TITLE: **COMPREHENSIVE PLAN AMENDMENT NO. 05001**,
by the Interim Director of the Public Works & Utilities
Department and the Lower Platte South Natural
Resources District, to amend the 2025 Lincoln/Lancaster
County Comprehensive Plan, to include the Stevens
Creek Watershed Master Plan as a subarea plan, and to
adjust the Future Land Use Plan accordingly.

**PROPOSED TEXT REVISION TO THE MASTER PLAN
TO INCORPORATE MOTION TO AMEND #1
BY PLANNING COMMISSION**

**PROPOSED AMENDMENT TO FIGURE 10-1 OF THE MASTER PLAN
TO INCORPORATE MOTION TO AMEND #2
BY PLANNING COMMISSION**

P.A.S.: Comprehensive Plan Amendment #05001 Stevens Creek Watershed Master Plan

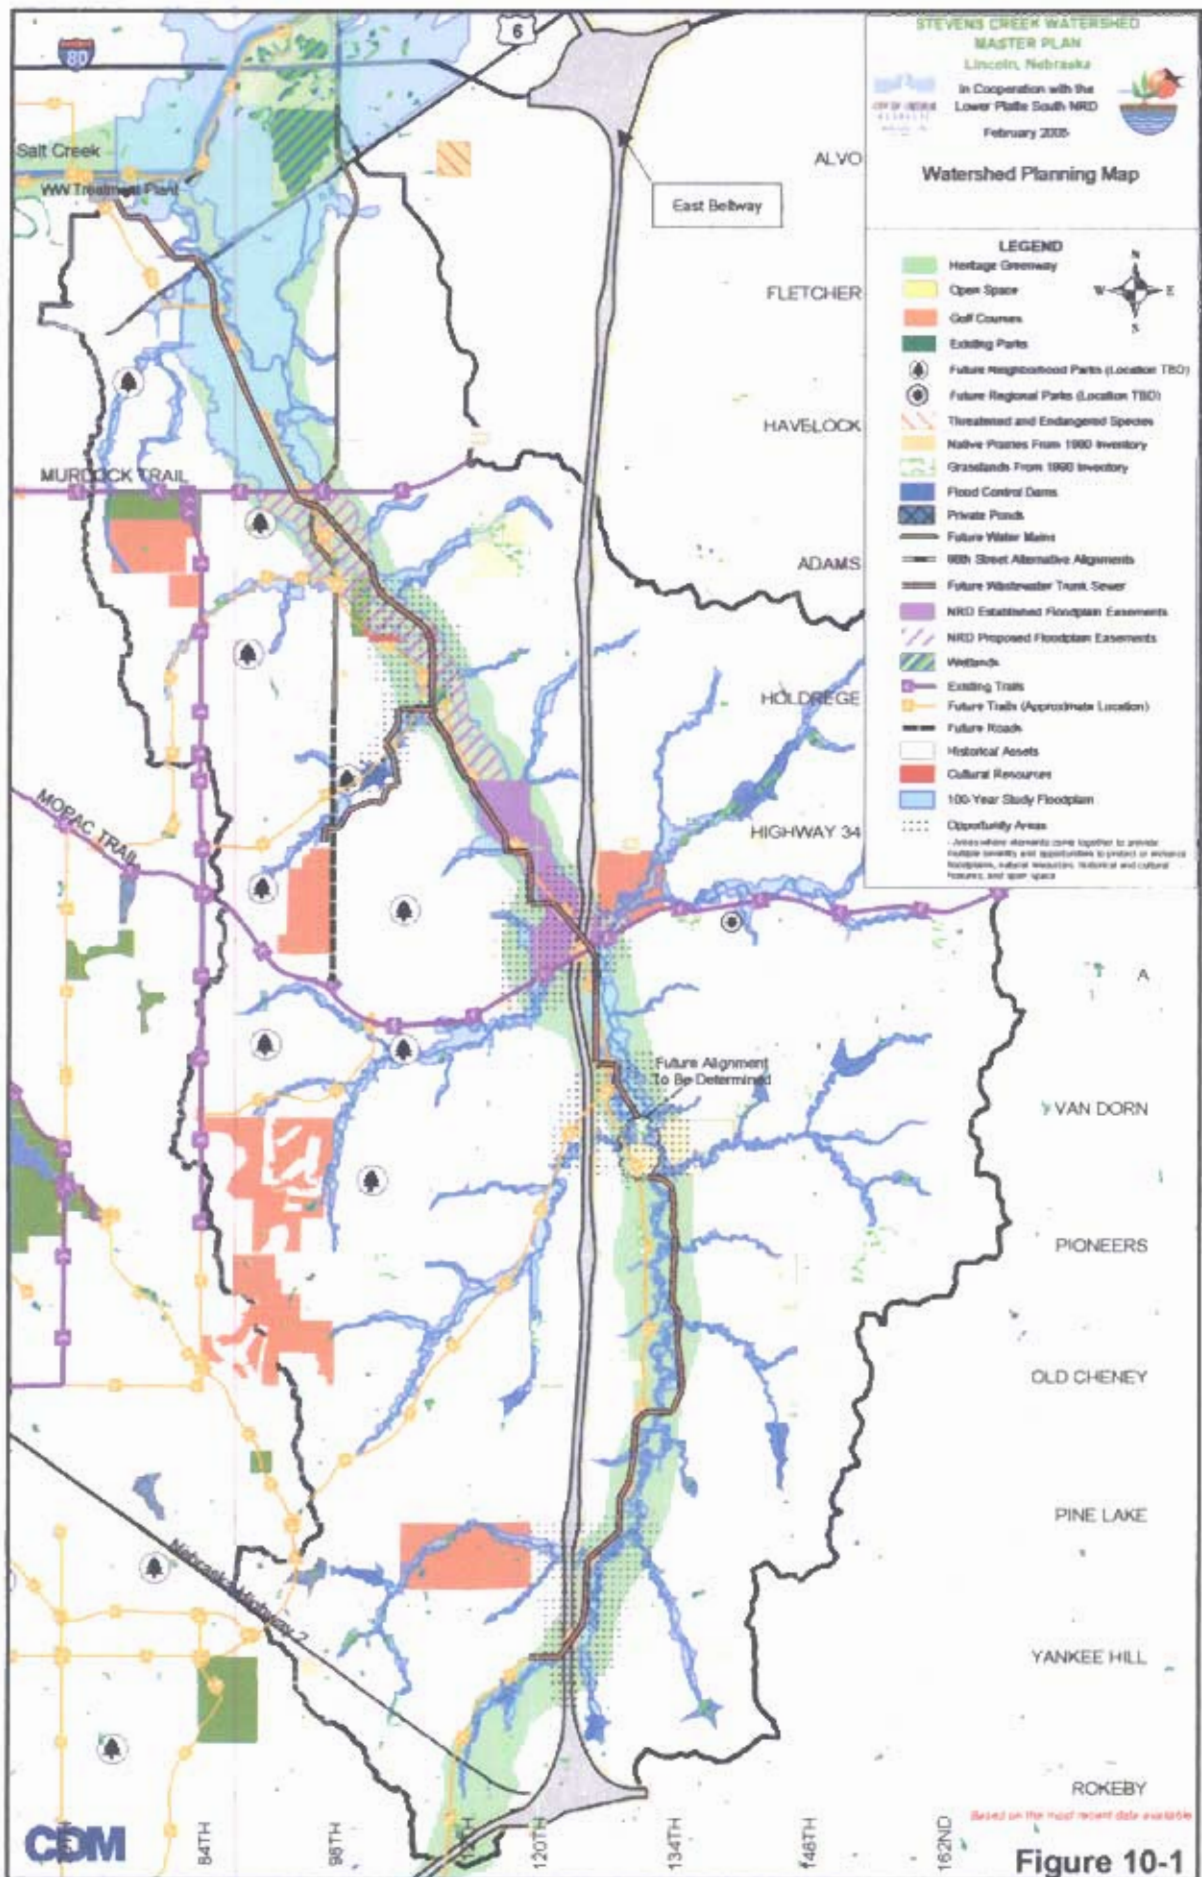
MOTION TO AMEND #1 (Mary Bills-Strand) that "all low cost options will be looked at and given an opportunity to be chosen by the developer, if it meets the (water) quality needs."

Revise the Executive Summary by adding a sentence to the end of the first paragraph on Page ES-8 as follows:

Two alternative methods were generated to install BMPs in the watershed based on a range of approaches discussed with the Citizen Advisory Committee. The methods included 1) Regional Structural BMPs, and 2) Site-Specific Structural BMPs. Advantages and disadvantages for each method were evaluated, which included an analysis of cost and effectiveness. The evaluation is described in Section 6 of the Master Plan and resulted in selecting site-specific structural BMPs as the recommended alternative. This method provides a cost-effective approach to maintain the integrity of the natural streams, preserve water quality, and can be efficiently integrated in the City's current development standards. The Master Plan includes guidance for revisions to the City's design standards for site-specific BMPs, which would be applied consistently to all new developments. Section 7 of the Master Plan provides further details on how to integrate structural BMPs into new development sites. When revised design standards are drafted, all low cost options providing the same or greater water quality benefits should be considered and included as options for the developer.

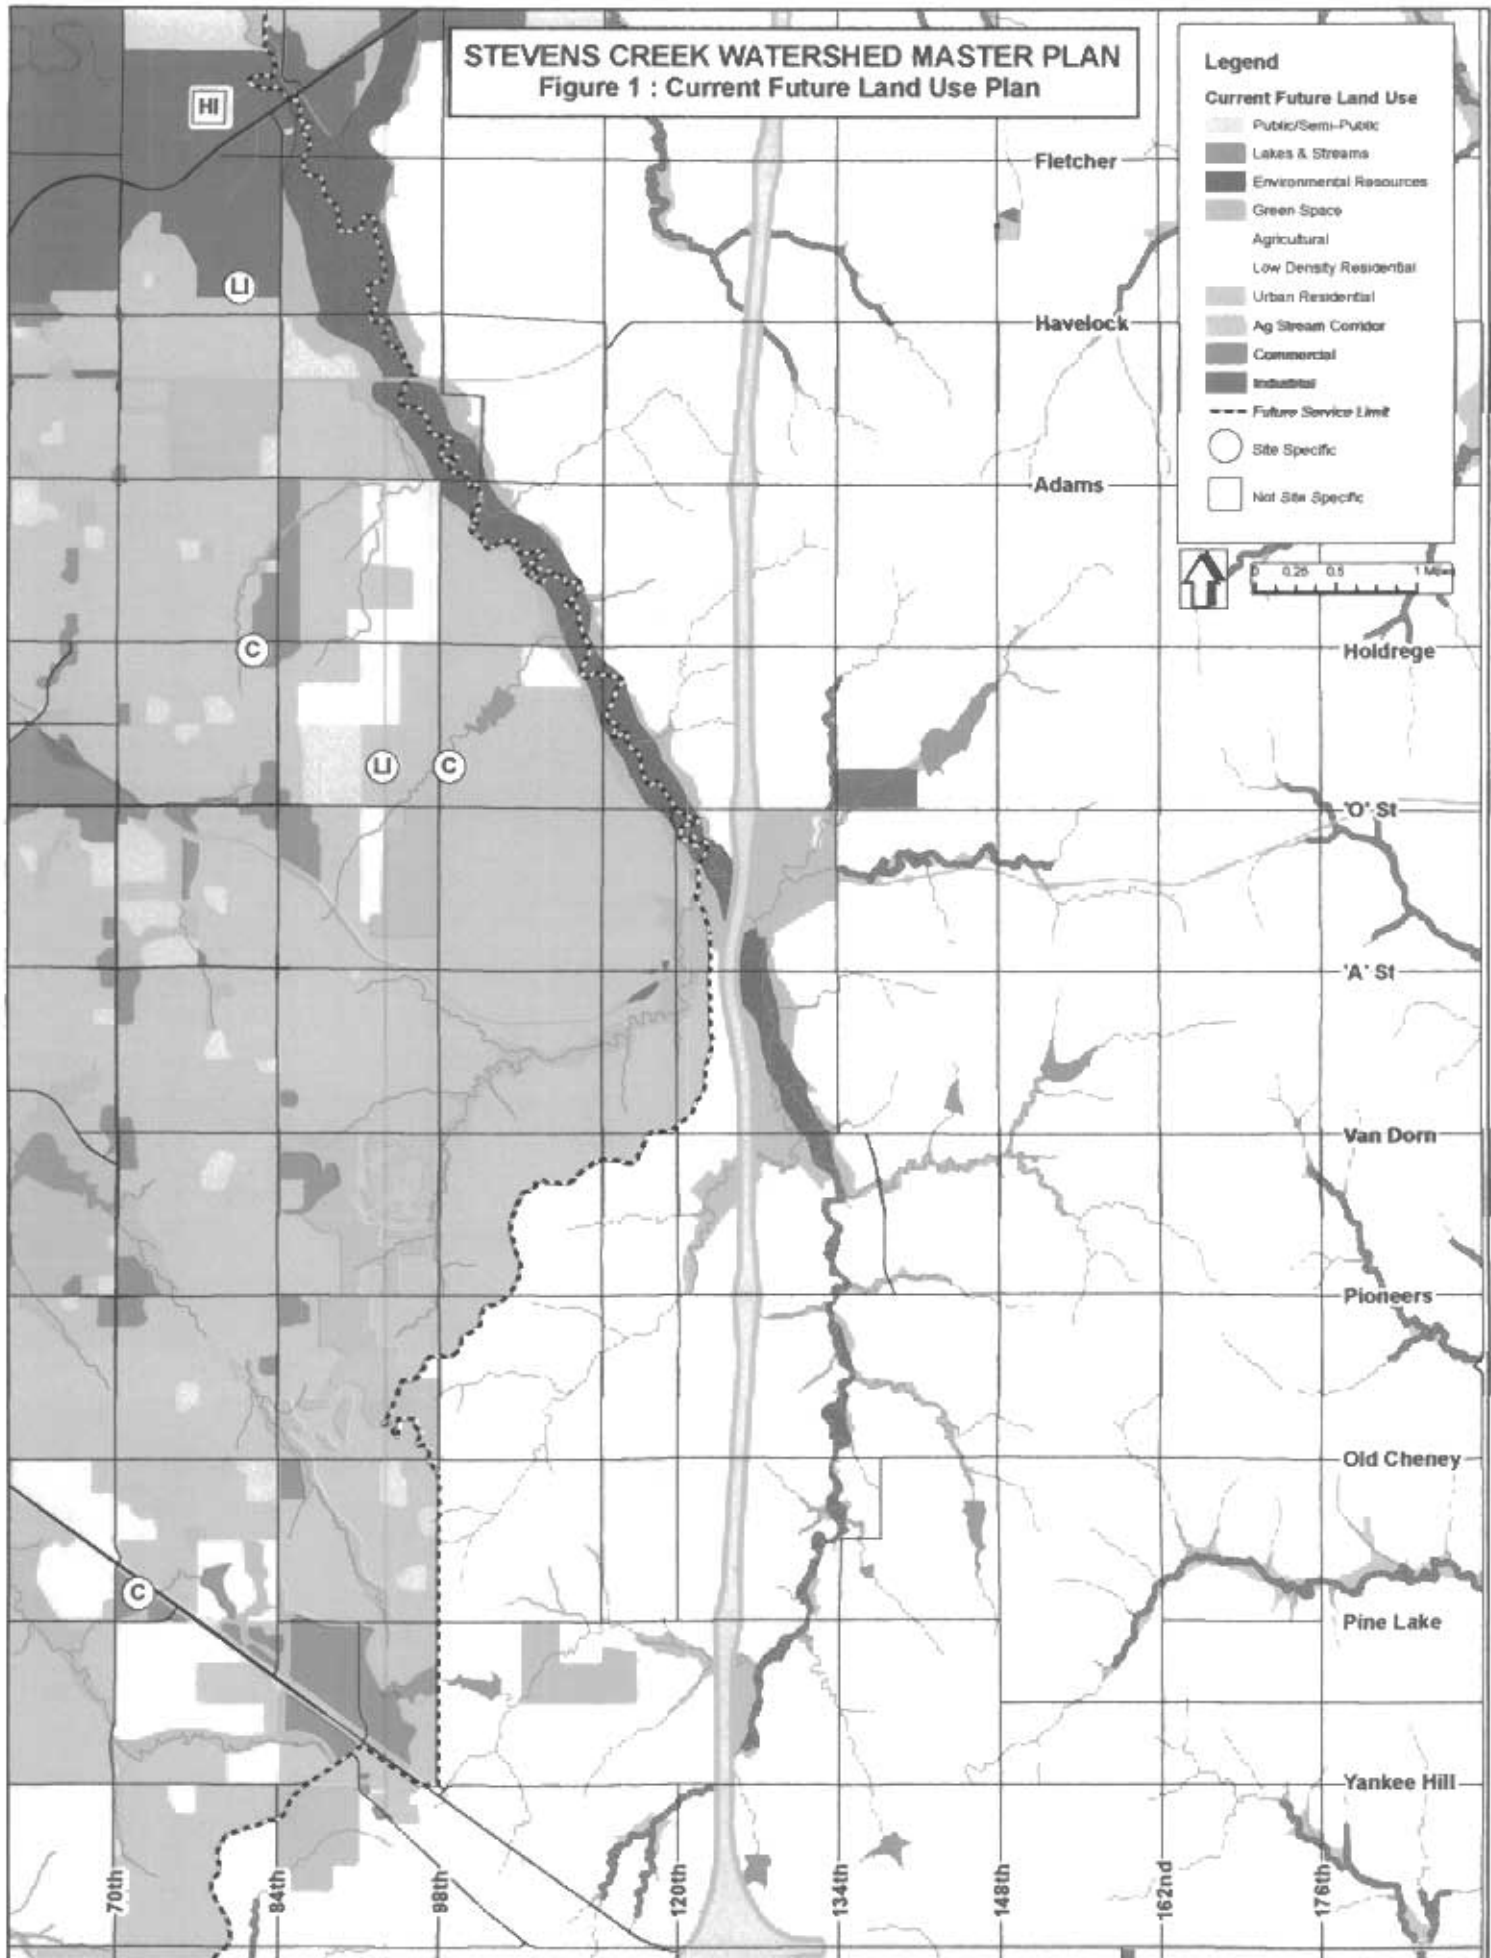
- #2 Carlson moved to amend that the approximate location of the sewer line on the map on ES5 be amended such that it is not shown to be running across the historic prairie, seconded by Bills-Strand. After further discussion, Carlson stated that he did not want to change his motion but suggested that if the motion carries, it will be up to the applicant to move it or delete it from the map. Motion to Amend #2 carried 7-2: Sunderman, Krieser, Larson, Marvin, Carlson, Pearson and Bills-Strand voting 'yes'; Taylor and Carroll voting 'no'.

Revise the Watershed Planning Map on Figure ES-5 and Figure 10-1 so that the future wastewater trunk line, which is shown on the map as a reference for potential future infrastructure, is noted to be determined in the future in the vicinity of Stevens Creek Stock Farm, as shown on the attached:

With regard to the Stevens Creek Stock Farm, Fleck-Tooze clarified that the future wastewater trunk sewer alignment is not being adopted with this plan; it does not preclude an alternate alignment; the future trail is from the trails master plan; the opportunity areas do not imply public access, but imply that there may be opportunity for parks or for private land to be preserved for open space or historic resources.

Carlson questioned the location of the trunk sewer line on ES5. Fleck-Tooze advised that to be the current preferred alignment, but this plan does not adopt the alignment and only shows it for information purposes. Wastewater is aware of the concerns that have been raised and will continue to work with Ms. Rickertsen as it moves forward. It would be at the point of design where we would look at the more detailed alignment. However, that is an issue that is separate from this watershed master plan. The alignment is not adopted with this master plan.
